FORT WAYNE COMMUNITY SCHOOLS 2025 GENERAL BUILDING SYSTEMS 2 (GBS2) – FOREST PARK, FRANKE PARK,

Addendum No. 01

February 10, 2025

Project No. 24047

Drawing FO-P2.1

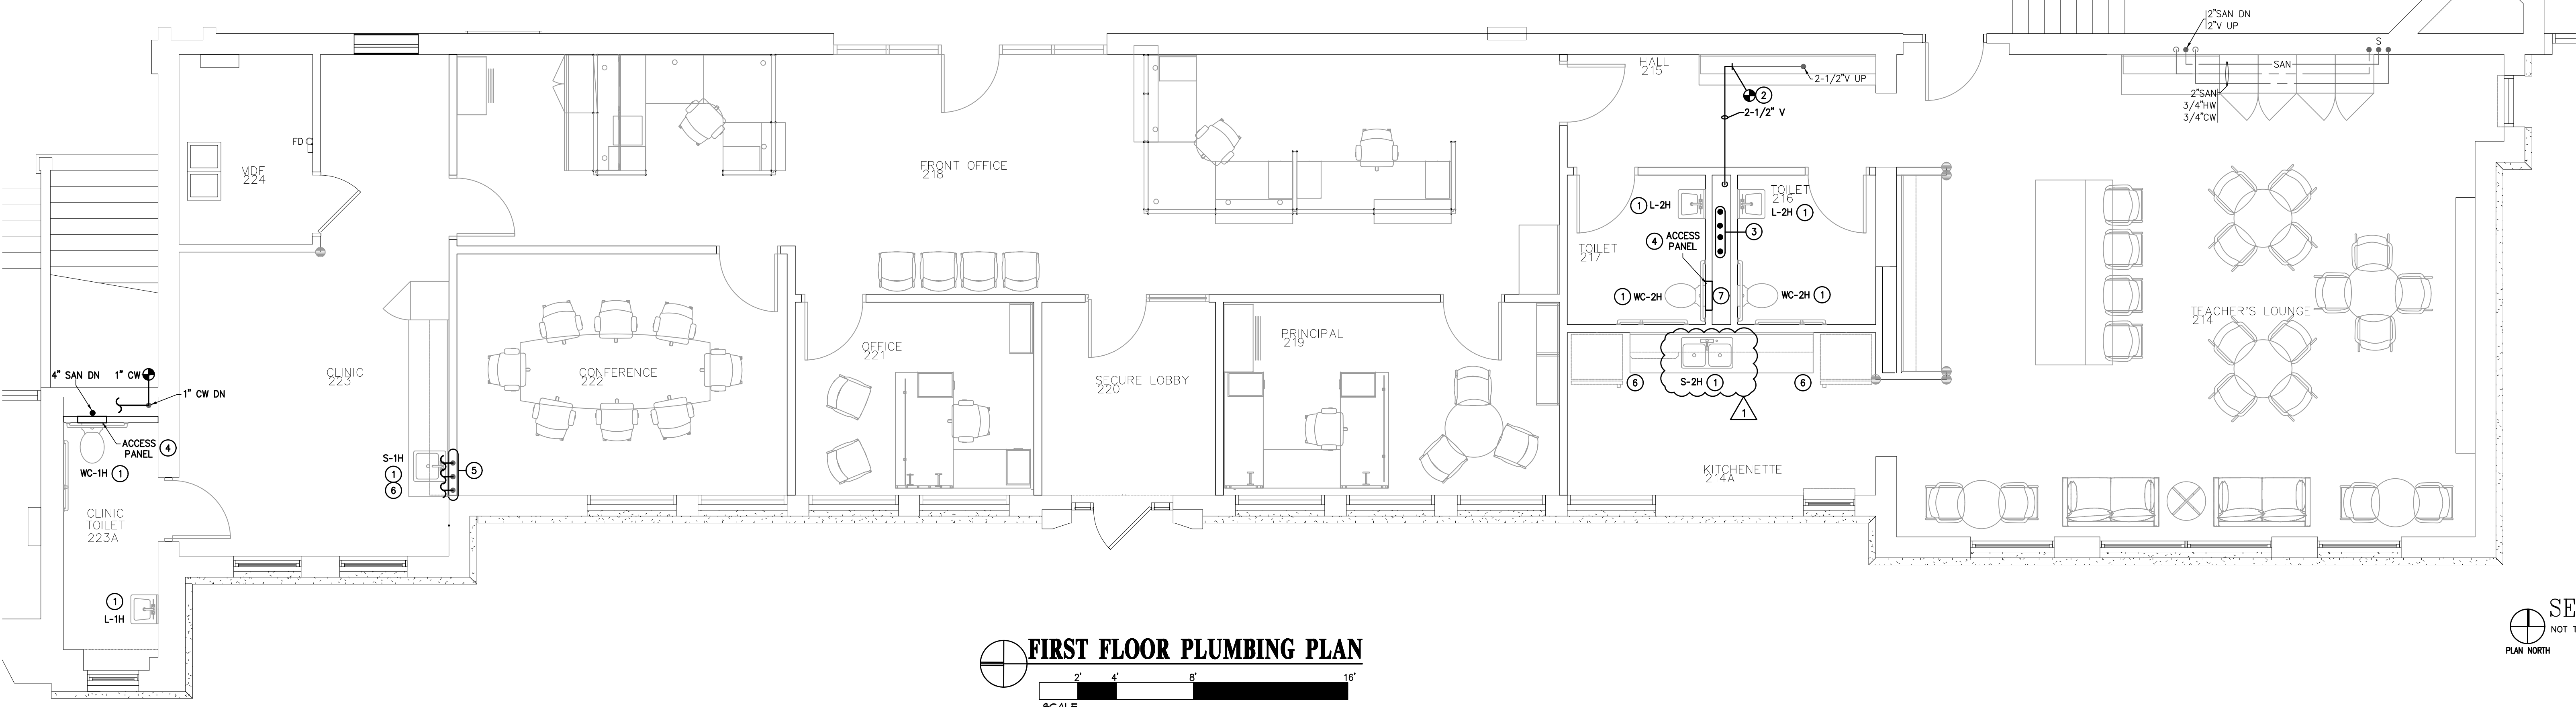
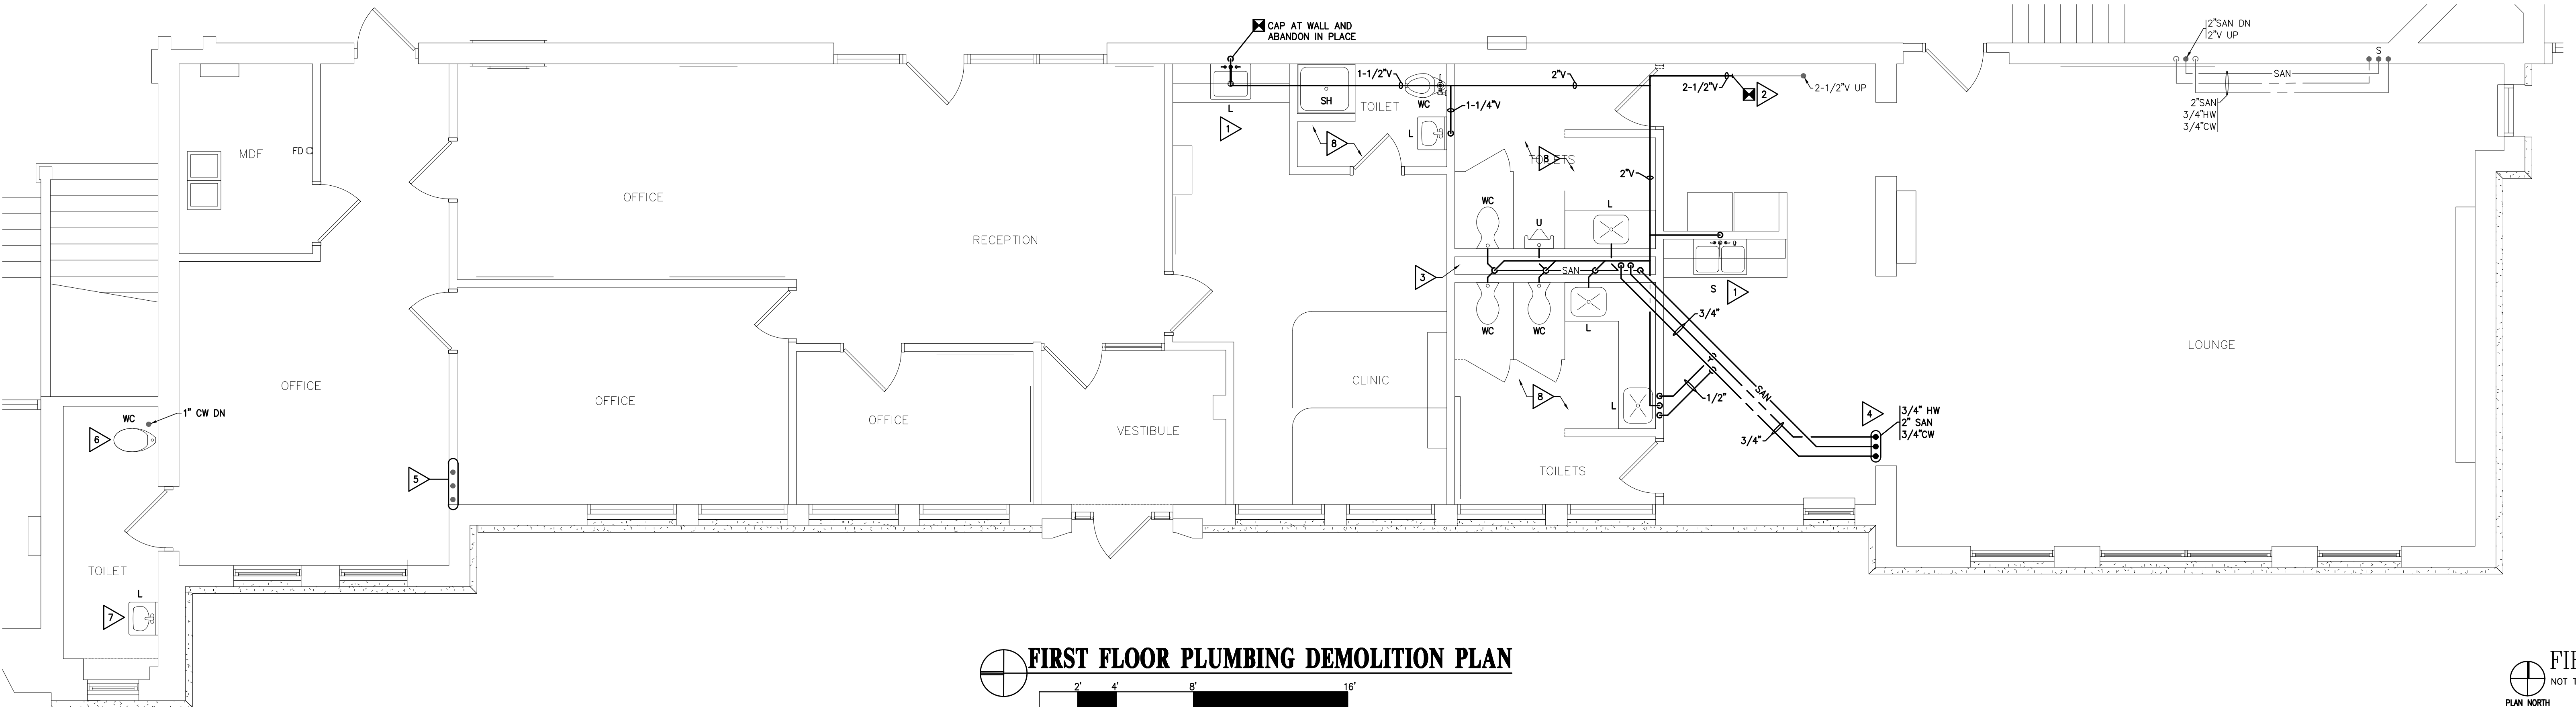
1. Contractor shall reference sheet FO-P2.1 for removal of garbage disposal associated with S-2H, per owner review.

Drawing FO-M2.1

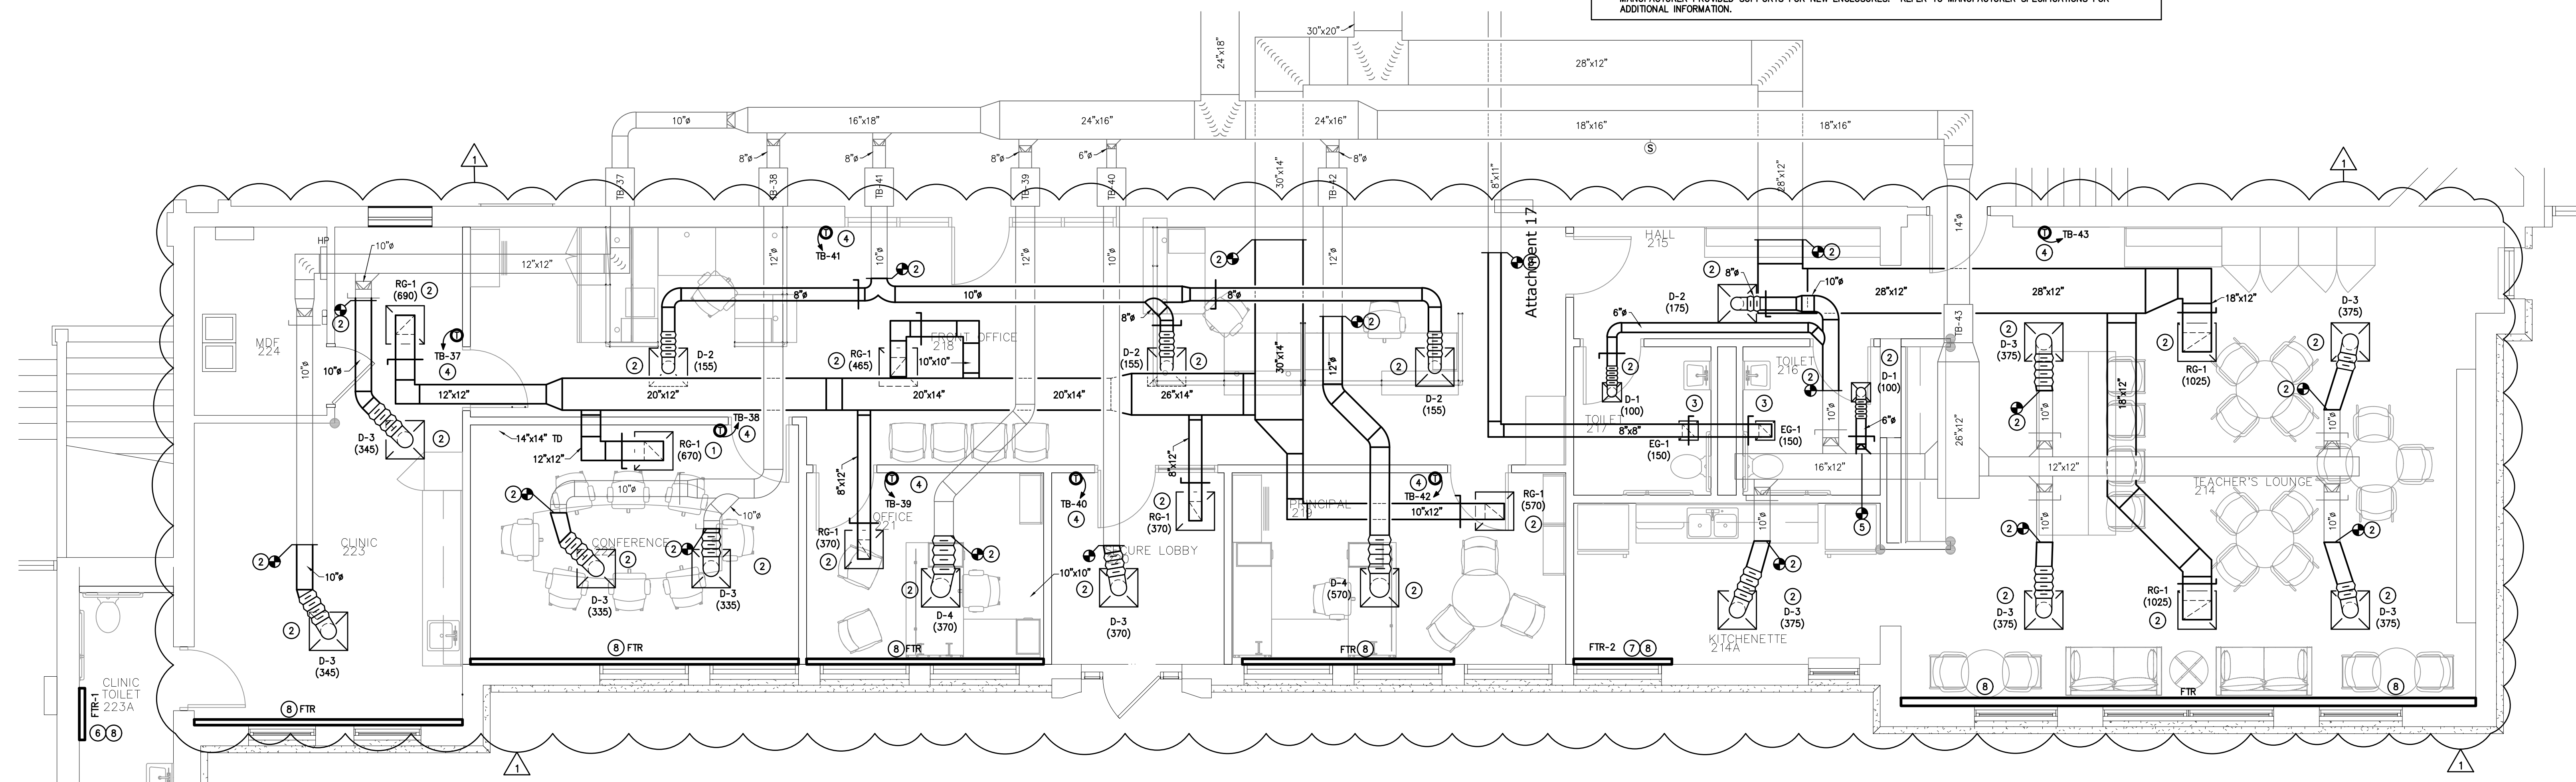
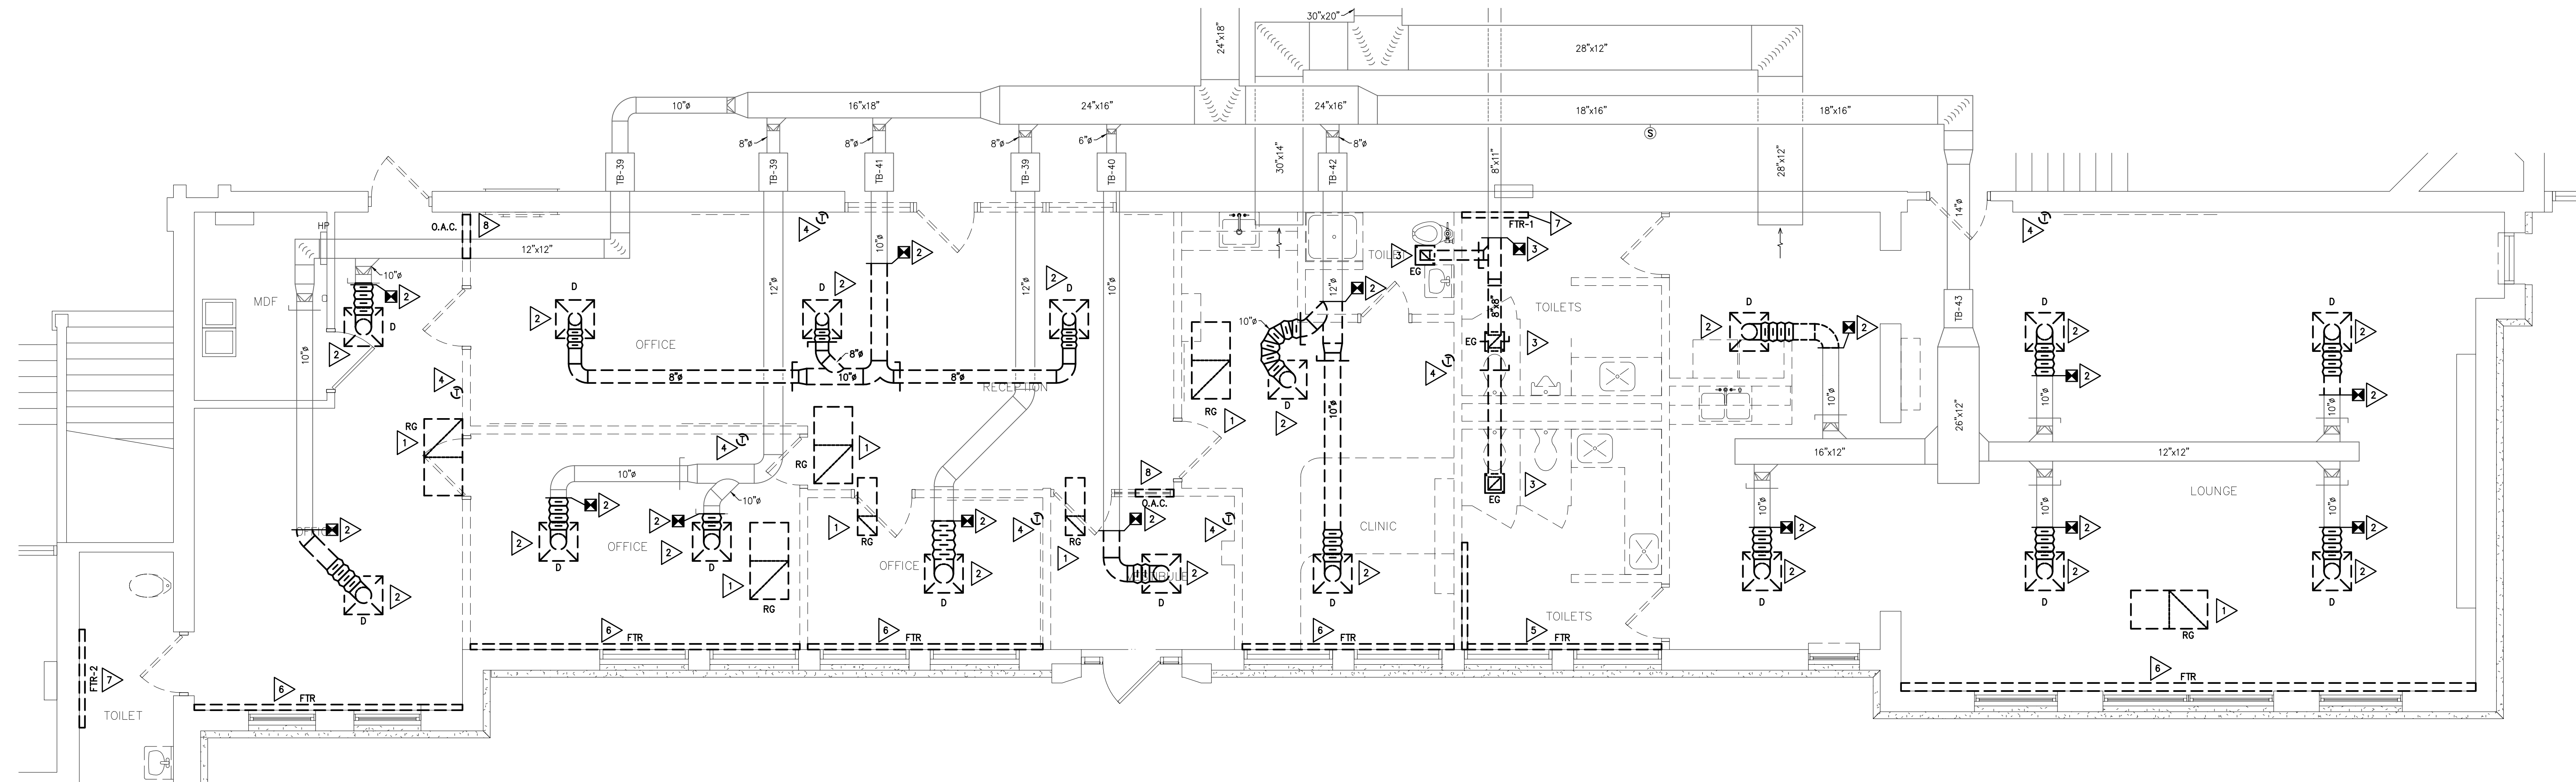
1. Contractor shall reference sheet FO-M2.1 for removal of all return grilles with duct boot from sheet, per owner review.

FO-E1.0

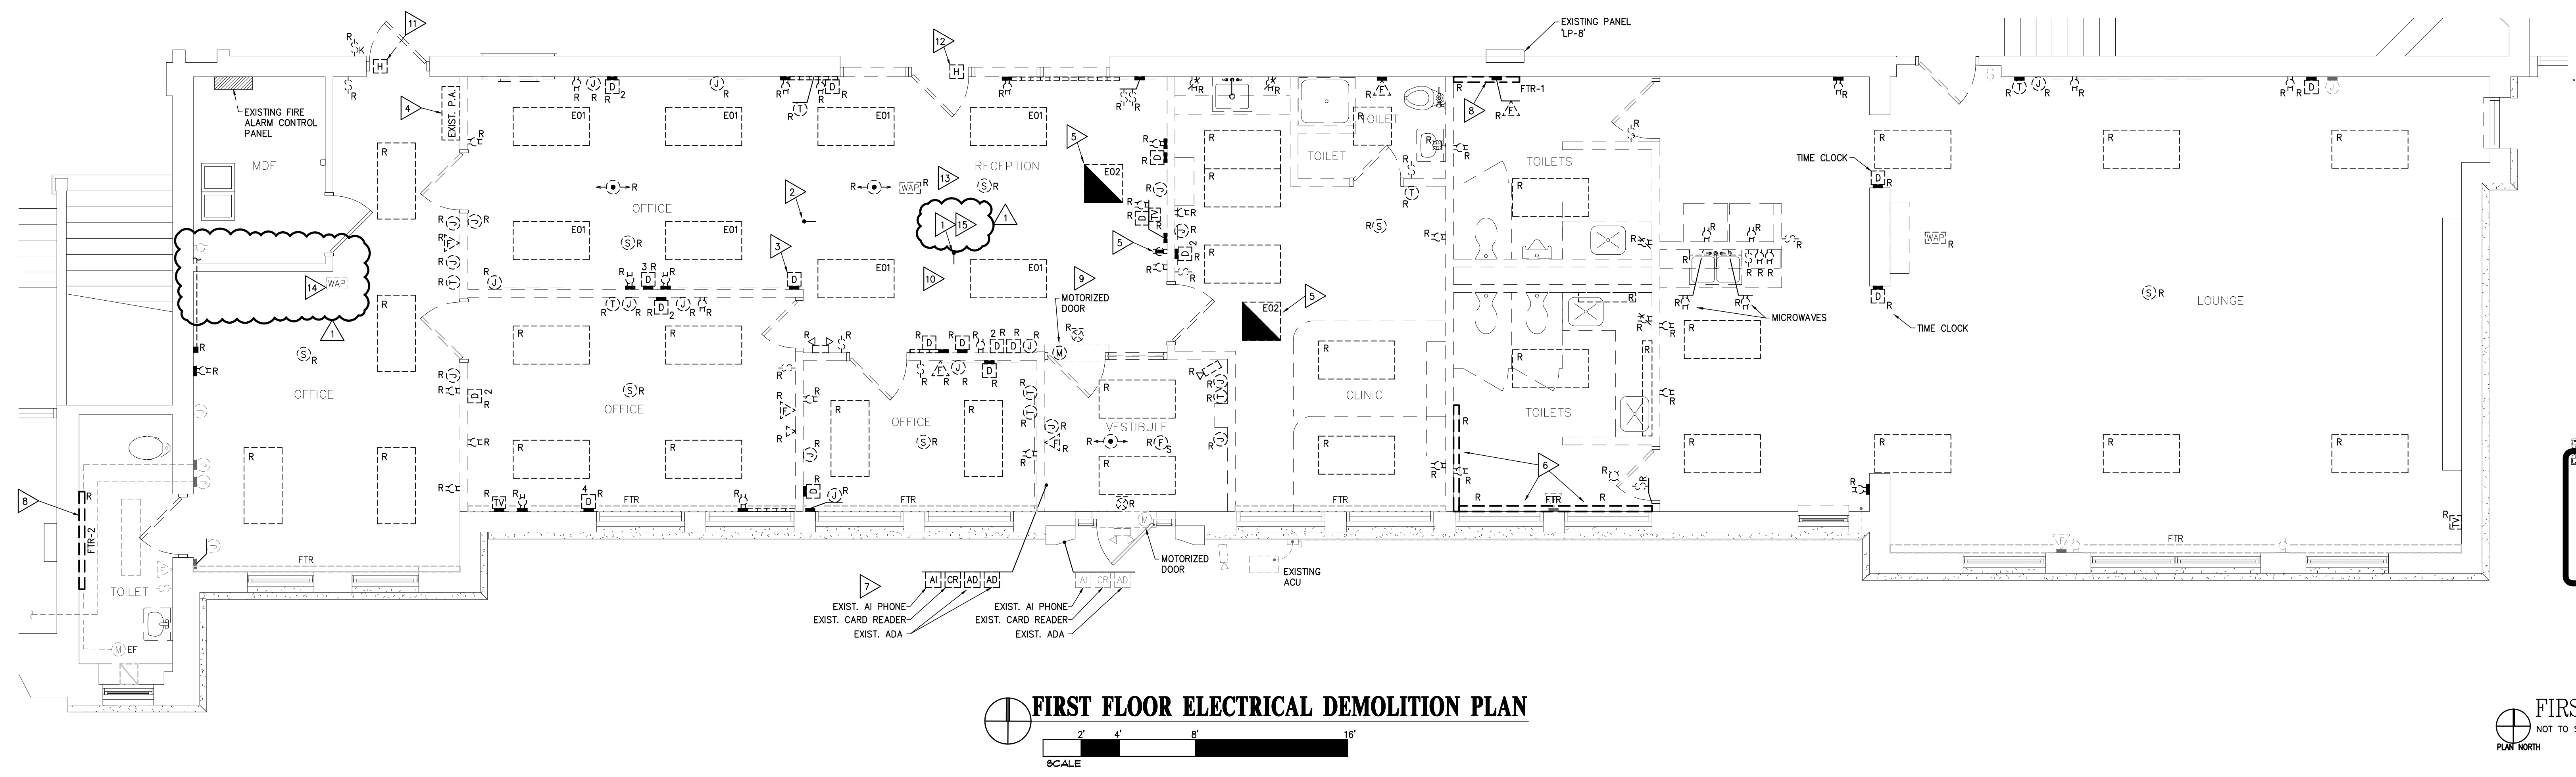
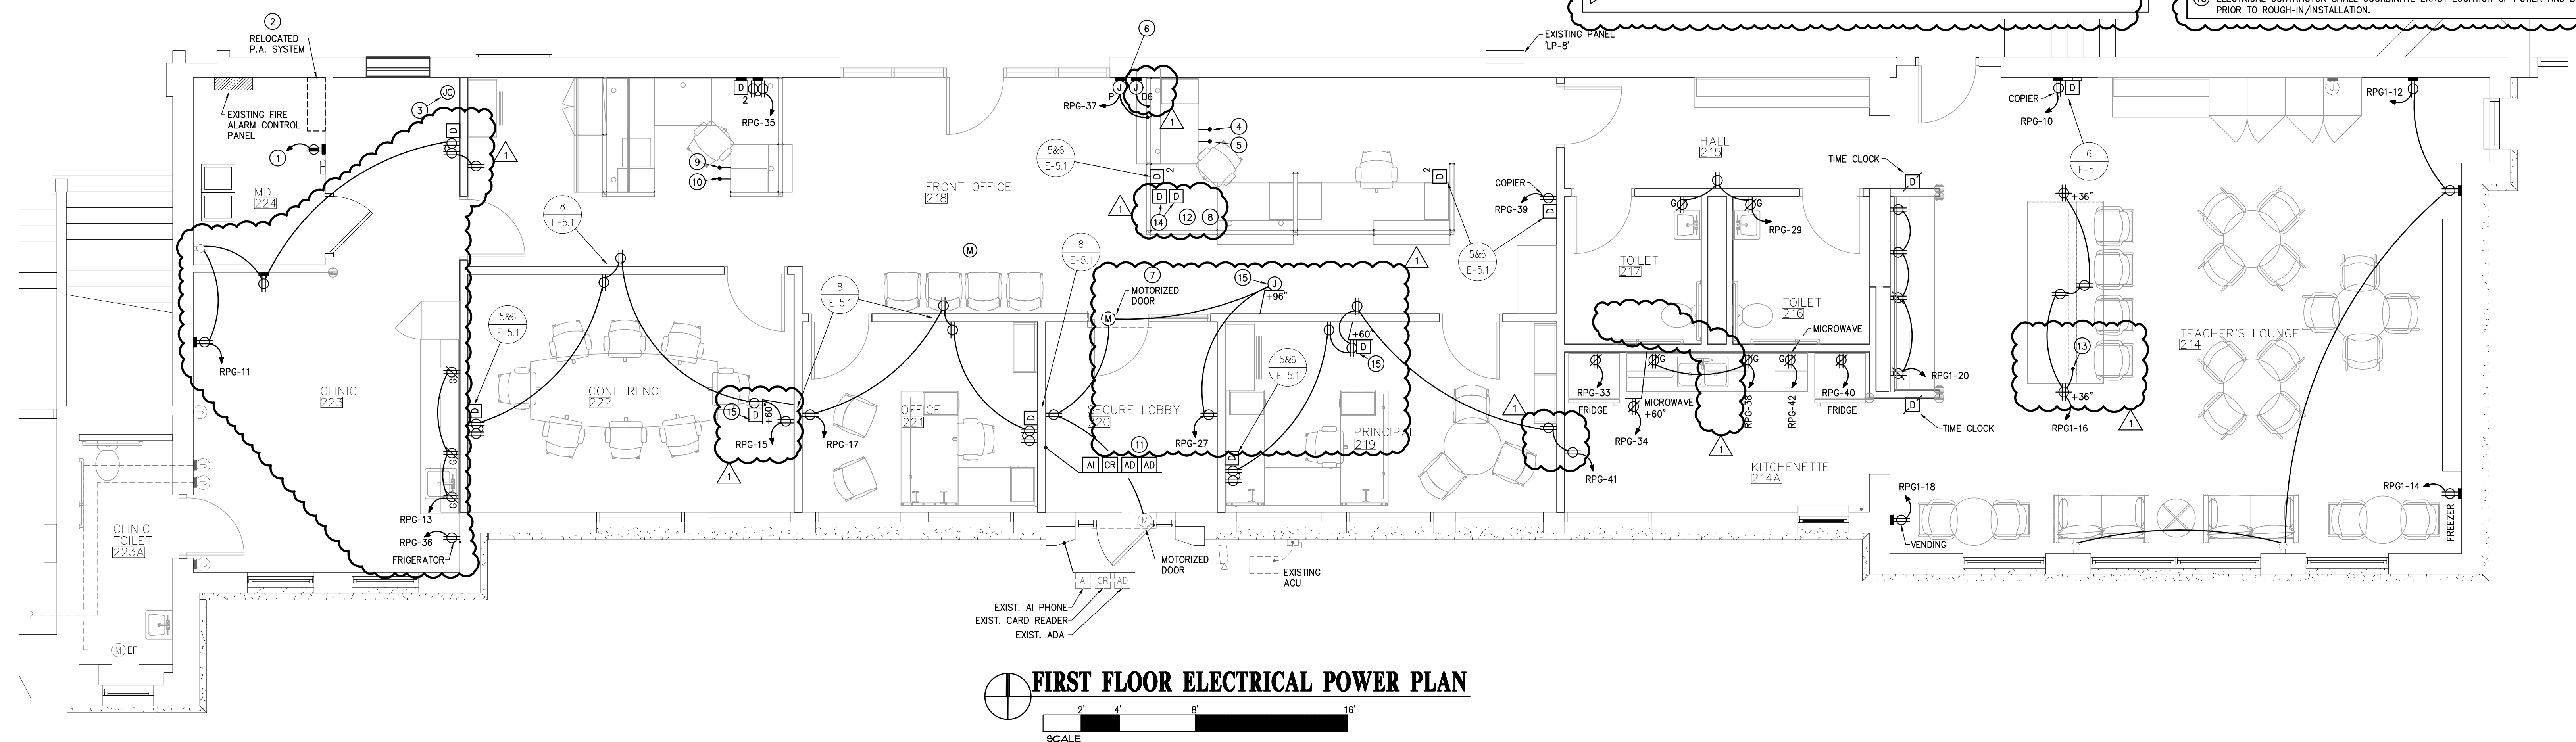
1. Contractor shall refer to revisions on this sheet reflecting owner review comments.
